ADDENDUM

Project: **Crestwood School District
Crestwood High School
Field Building & Site Improvements**

Date: **March 27, 2023**

Addendum Number: **#2**

3 Building B Elevation (North)
3.01 Scale: 1/4"=1'-0"

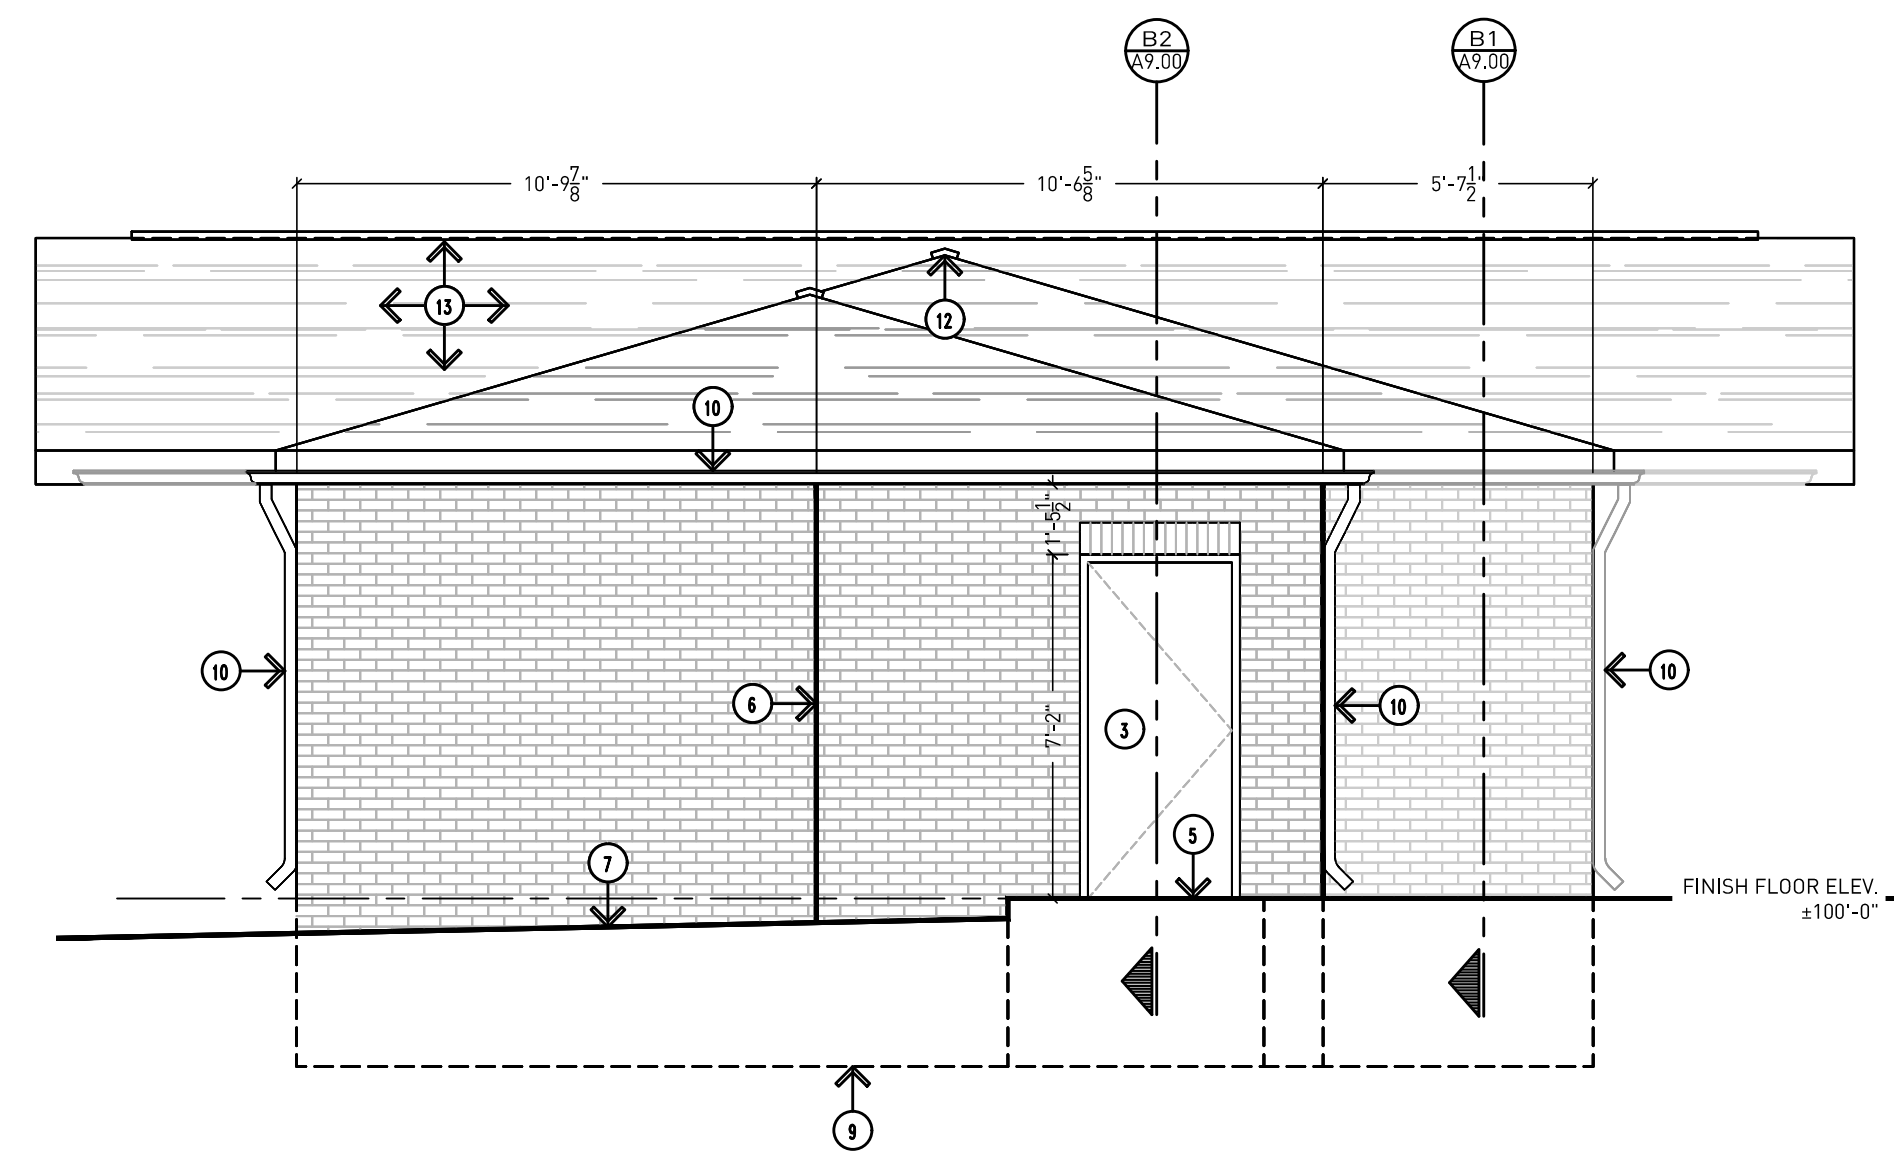
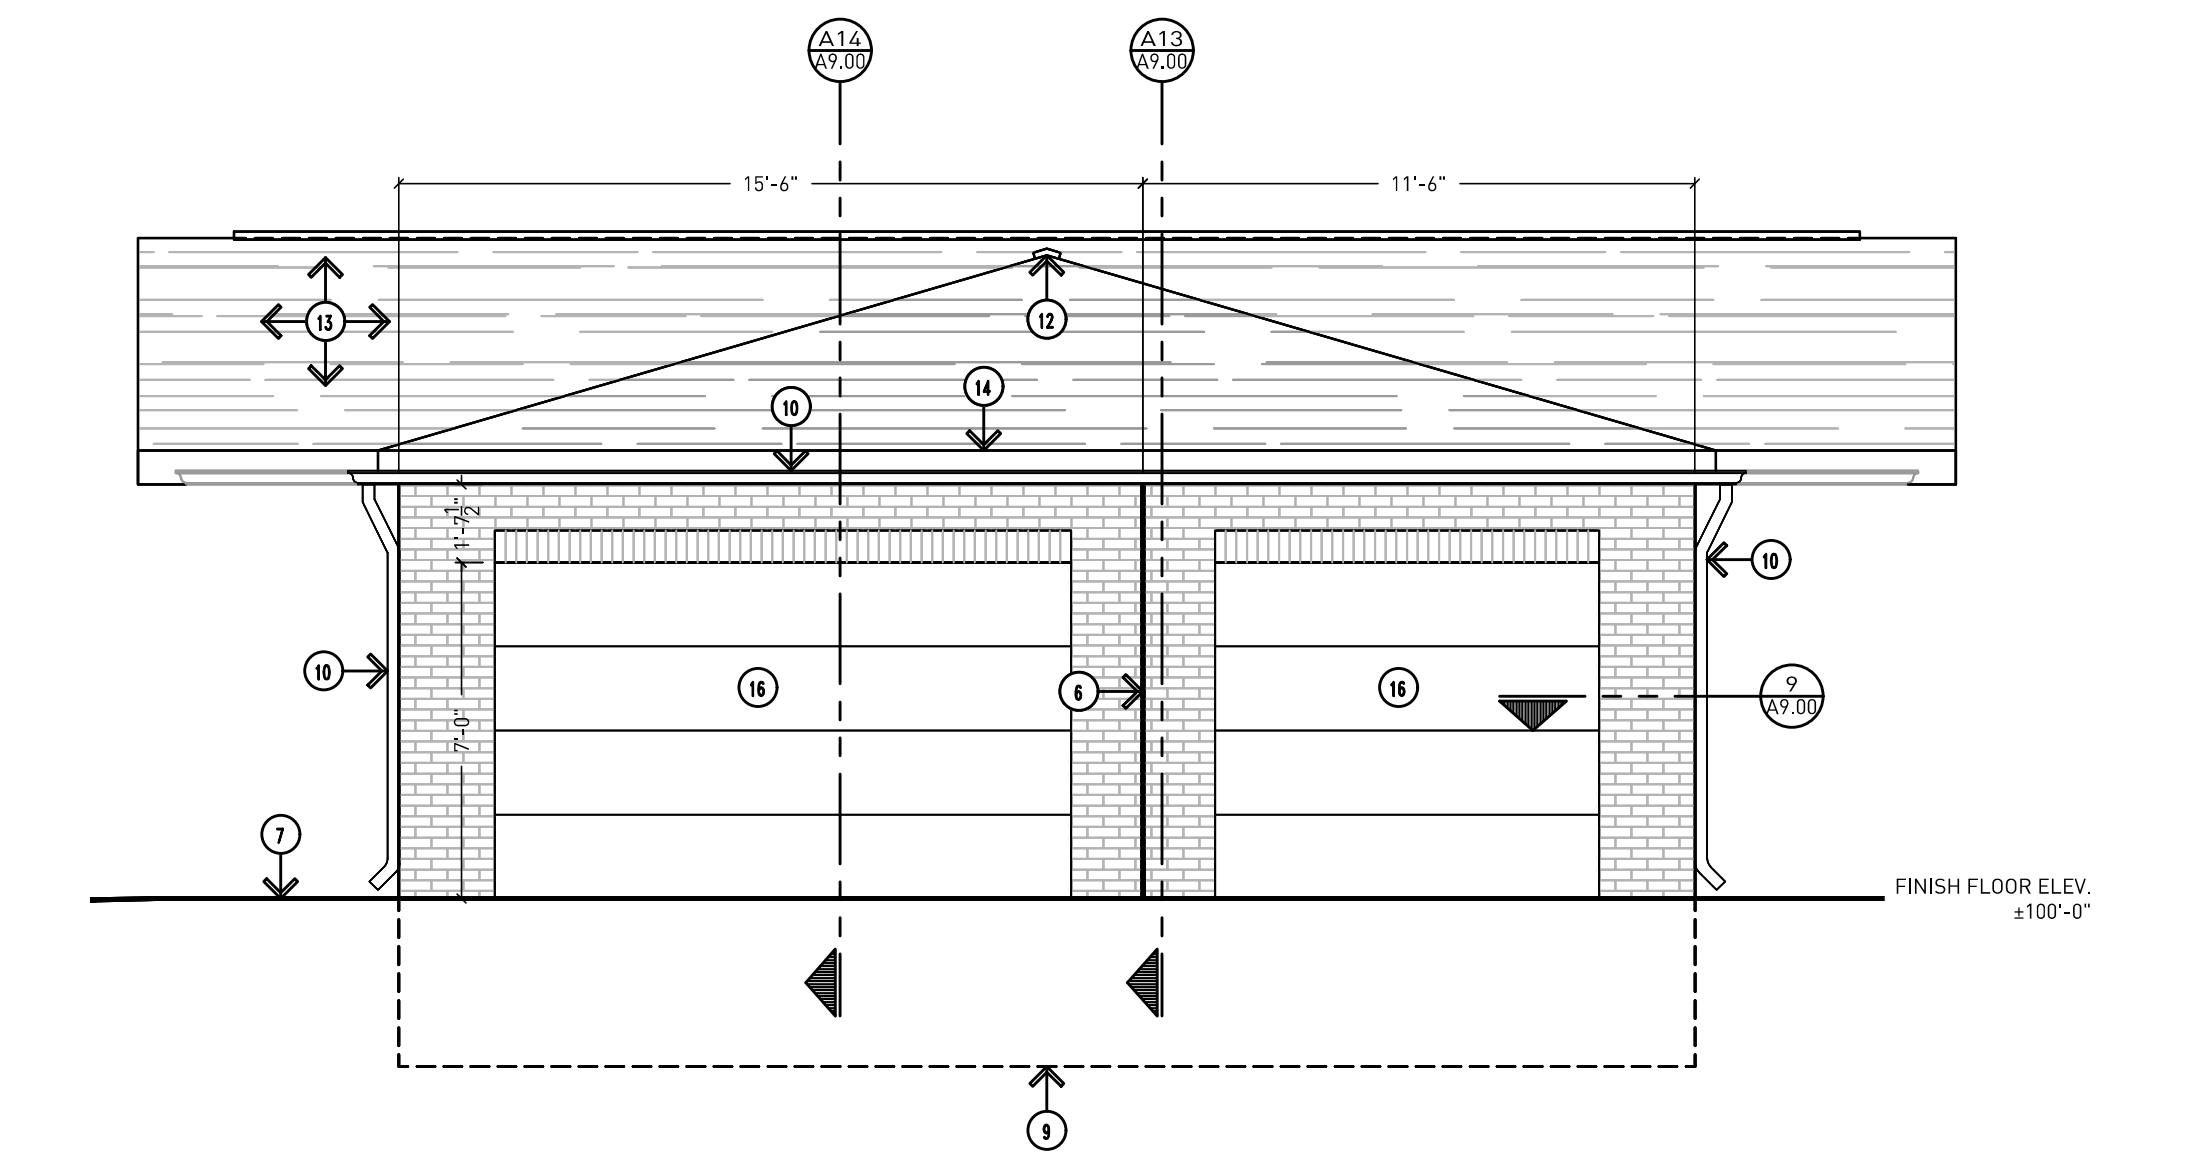
A3.00 – Exterior Elevations

CHANGE:

- FROM:** 4" brick veneer to match existing (install header course every 6 rows of brick). — color to Belden Brick "1-HB".
- TO:** 4" brick veneer to match existing (install header course every 6 rows of brick). — color to Belden Brick "Sandford".

A3.01

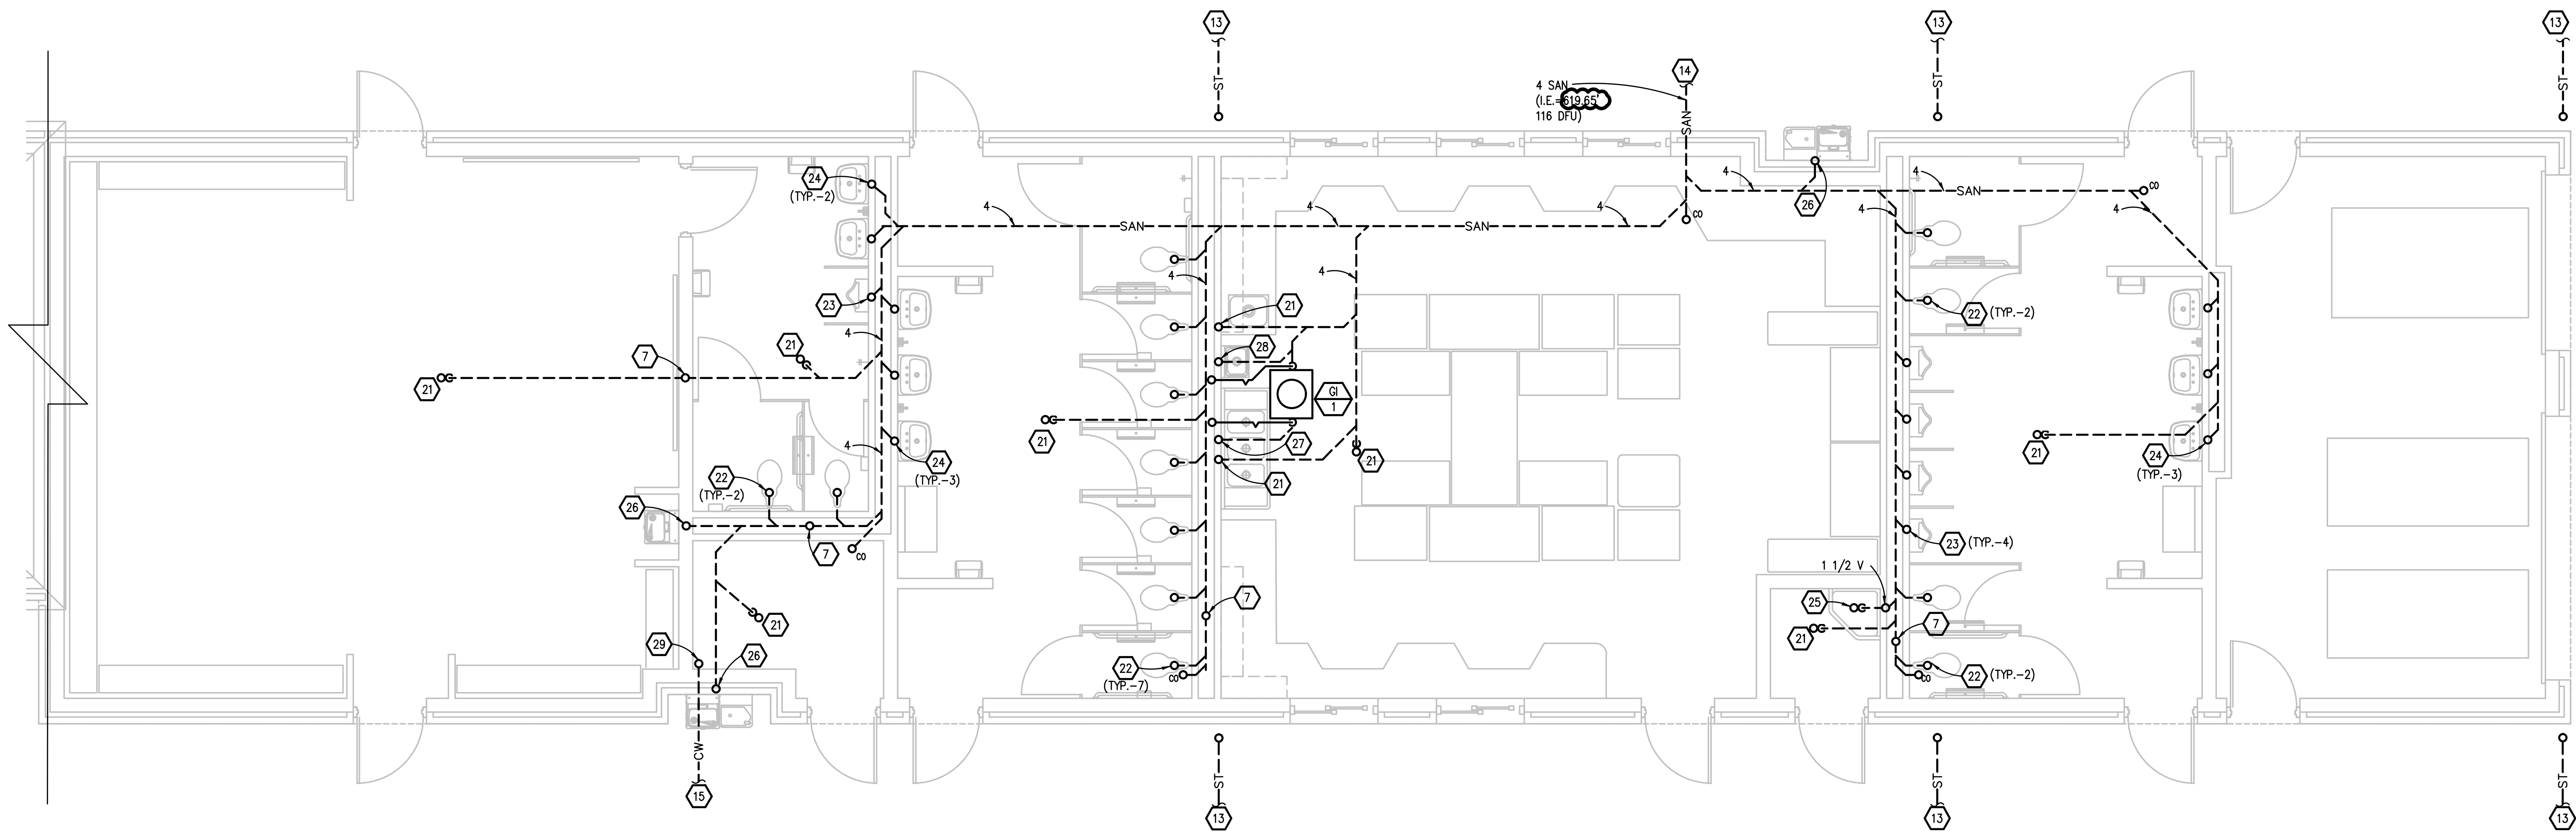
A3.01 – Exterior Elevations

CHANGE:

- FROM:** 4" brick veneer to match existing (install header course every 6 rows of brick). — color to Belden Brick "1-HB".
- TO:** 4" brick veneer to match existing (install header course every 6 rows of brick). — color to Belden Brick "Sandford".

M2.00

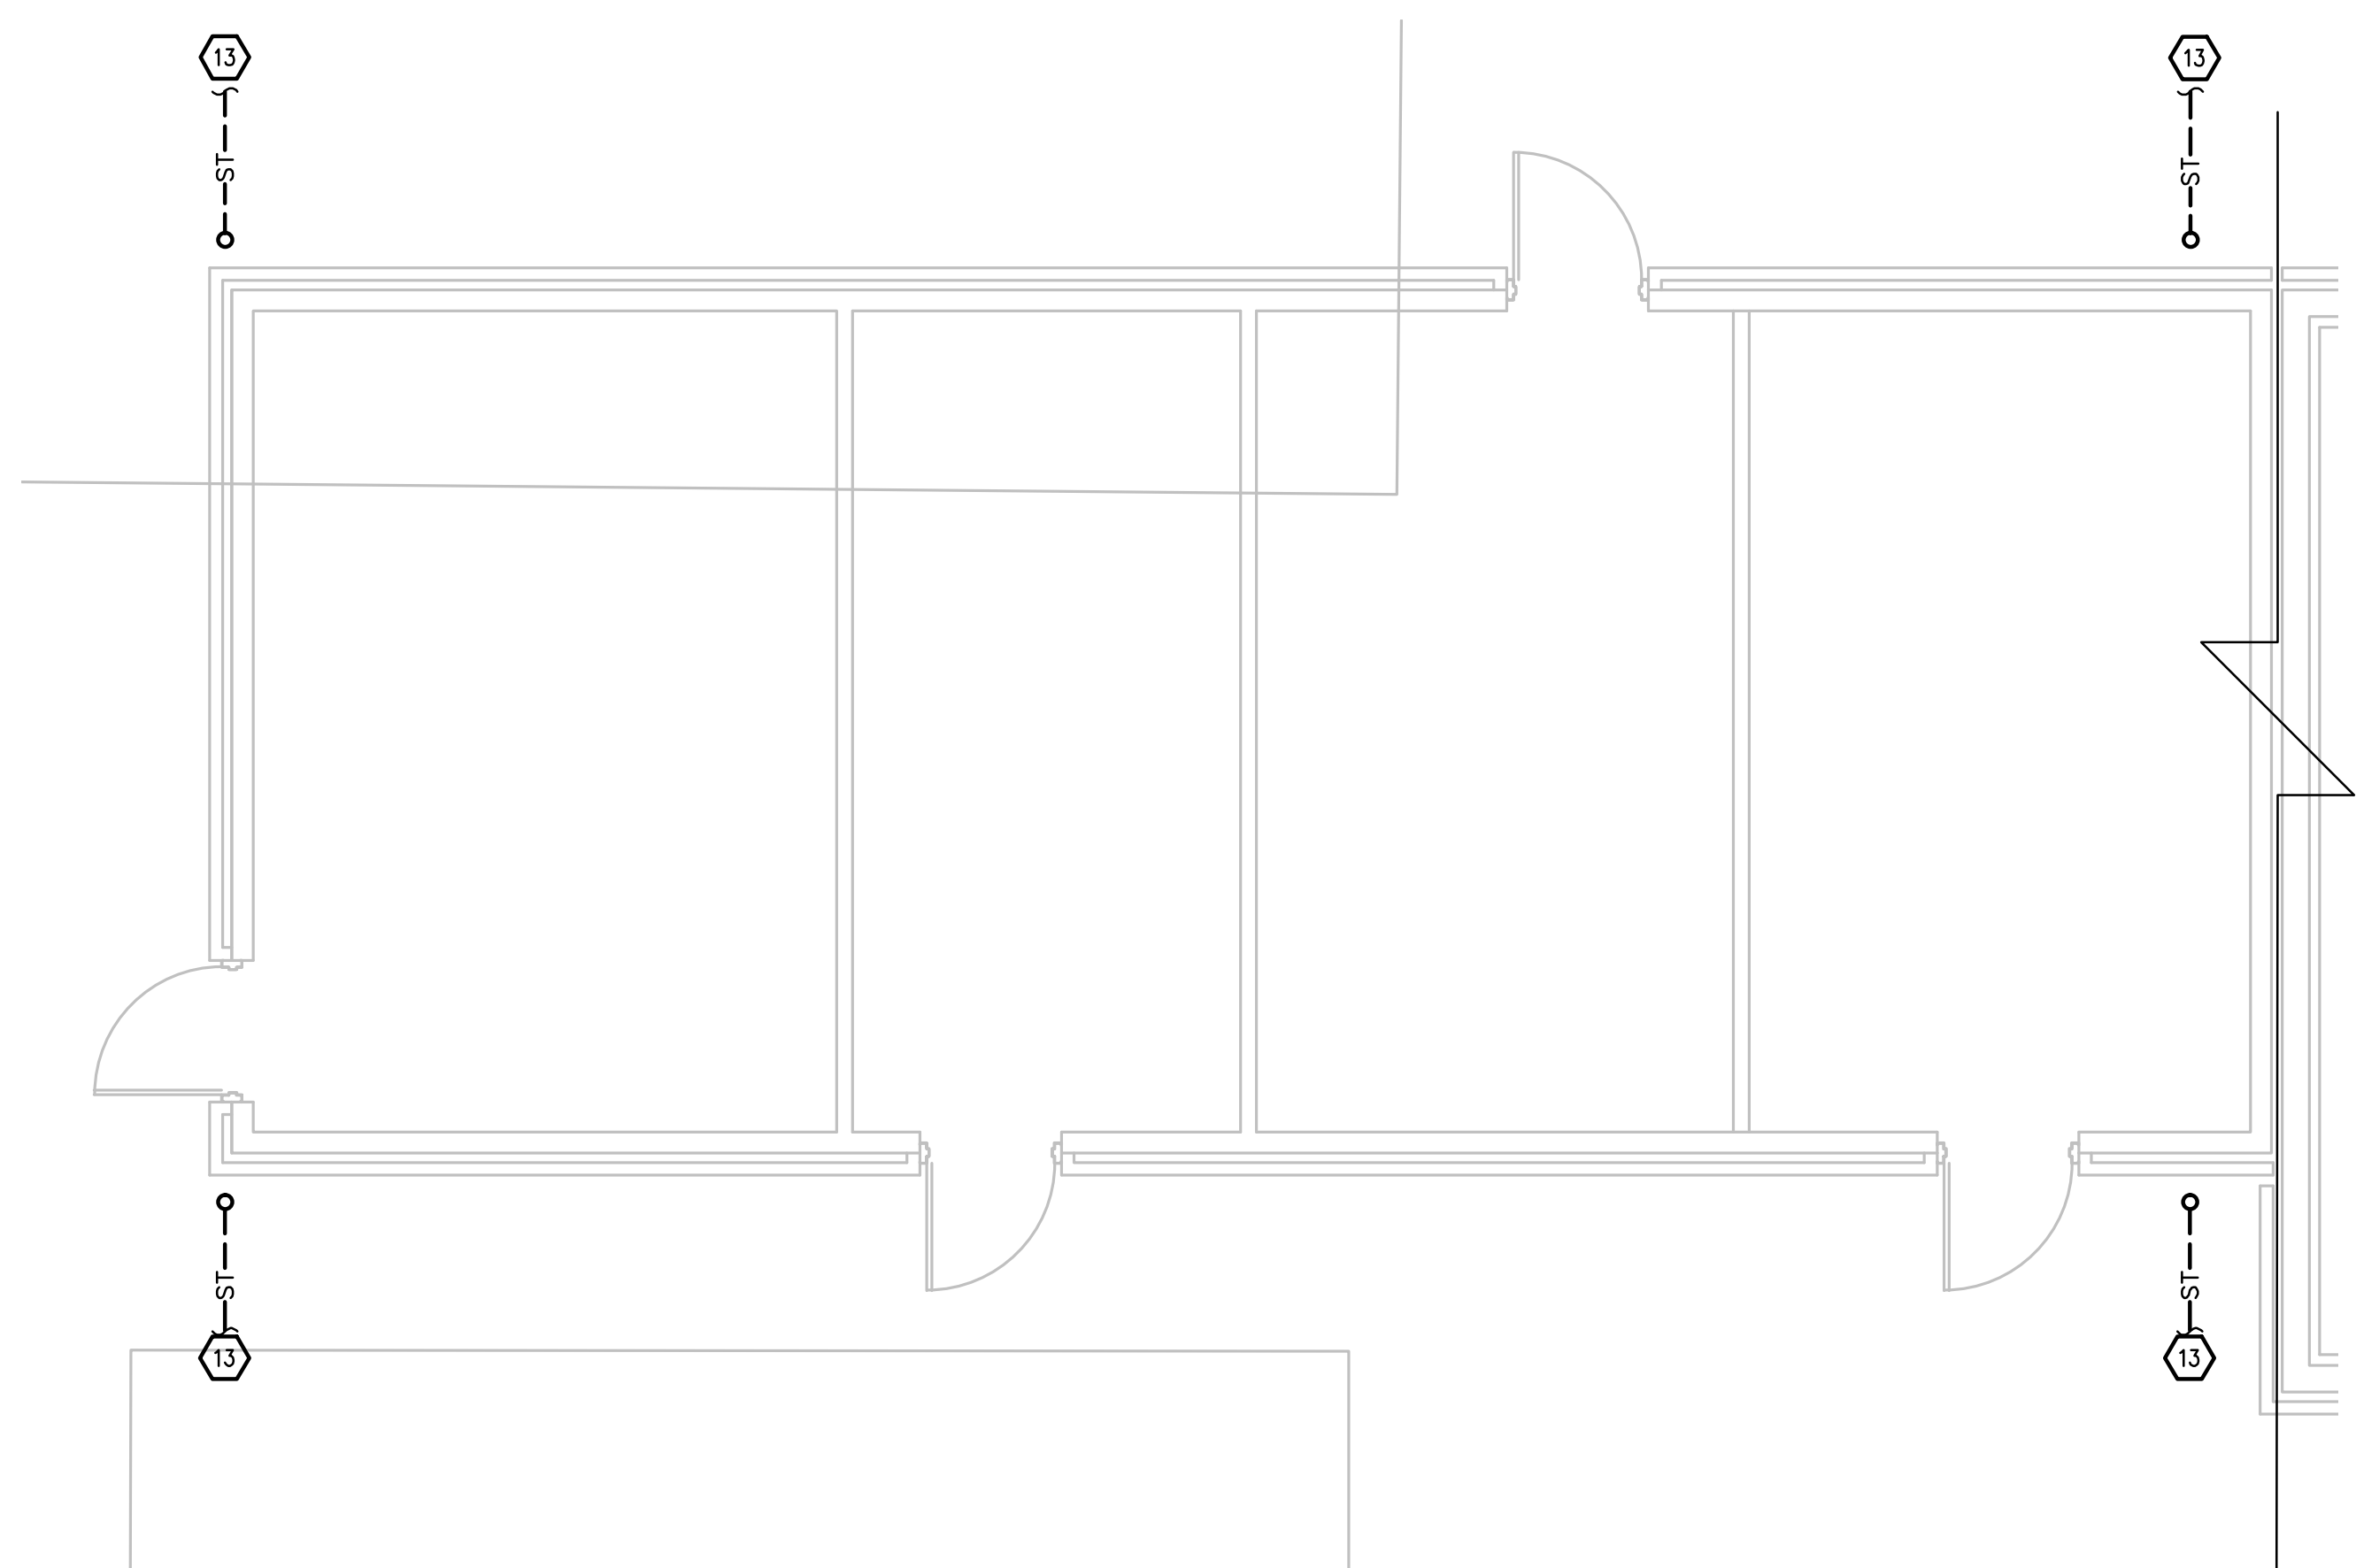
MD-1 Refer to Drawing M2.00 & M2.01 (Re-Issued)

1. Clarify Invert elevation of sanitary lead at Building A & B, as indicated.
